**CENTRAL-ALLIED ENTERPRISES INC.**

SUBJECT Voided Control Number  
07539

SUBJECT: REQUEST FOR AN NRC LICENSE DATED JULY 14, 1987 AND OUR  
NOTICE OF ABANDONMENT DATED JANUARY 15, 1988

We have reviewed your application date July 14, 1987, requesting an NRC license to possess and use portable moisture/density gauges and find that we will need additional information as follows:

# CENTRAL-ALLIED ENTERPRISES, INC.

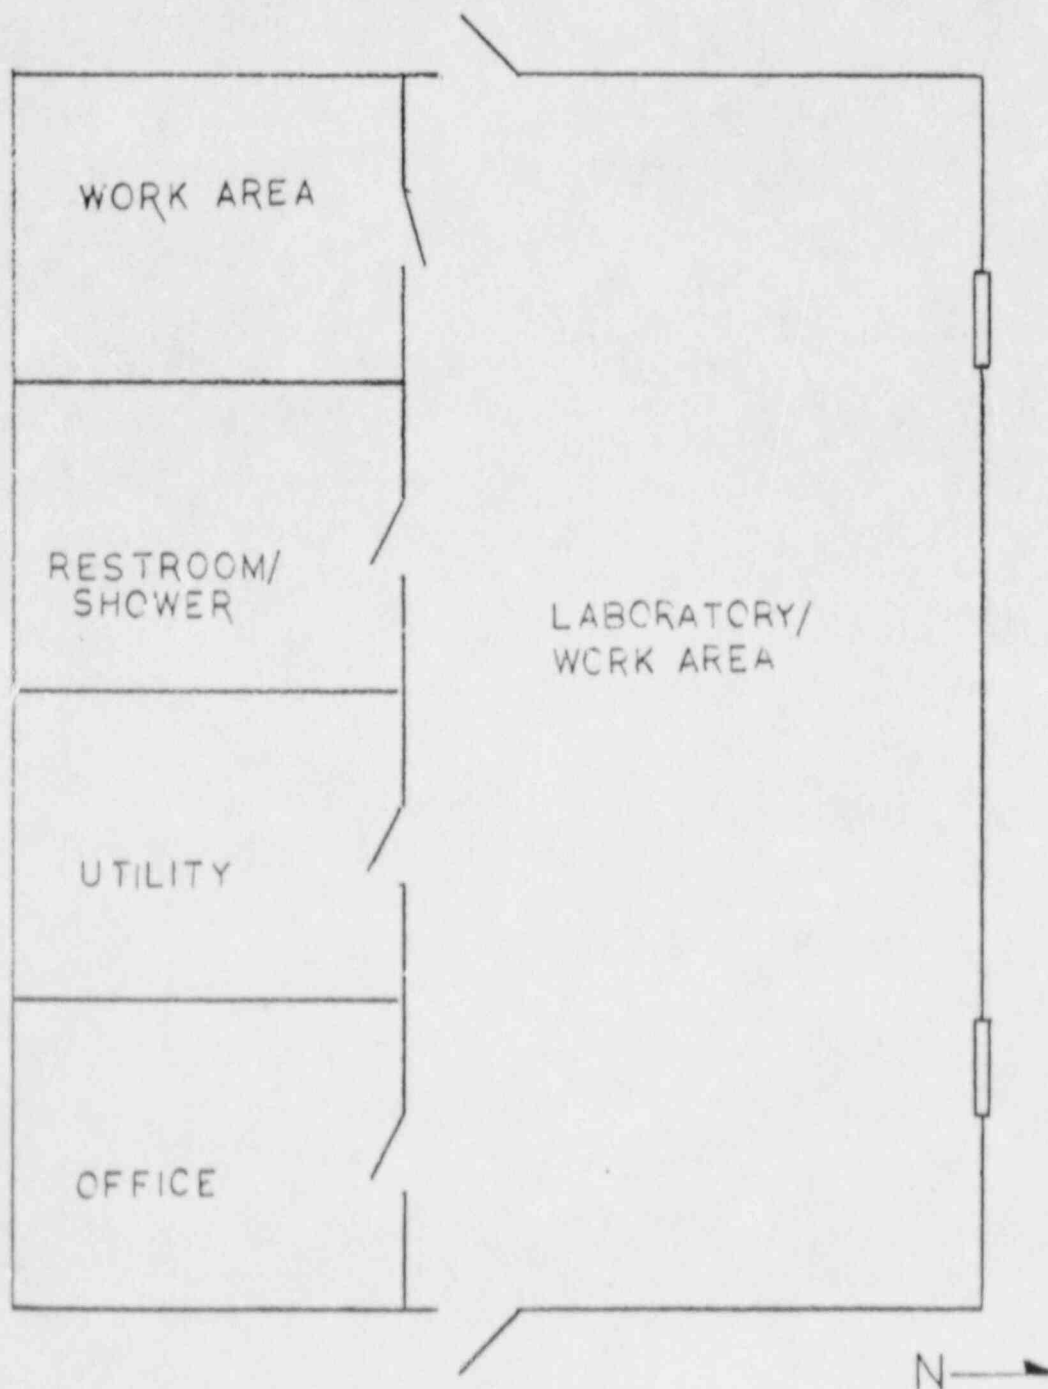
- a. Please submit a diagram of the area where the gauges will be stored at your permanent facility and describe the security of this area.
- b. Describe the storage provisions you have established for periods when the gauges cannot be returned to the established storage shed (e.g., extended jobs requiring overnight stay).
- c. Specify the location within the vehicle where the gauge will be stored during transport to and from job sites.

- A. Attached is a diagram of the area where the gauge(s) will be stored at our permanent facility.

Gauge(s) will be stored in the office as labeled on the diagram.

1. Security at this facility is as follows:

- a. Watchmen patrol premises after normal business hours until business hours of the following day.
- b. Building has an intrusion alarm system. Protection of building includes windows and doors. Alarm is monitored 24 hours a day by a manned central station. Alarm was installed and is maintained by ADT.
- c. Interior room doors are all lockable. The office door is keyed differently from all others.
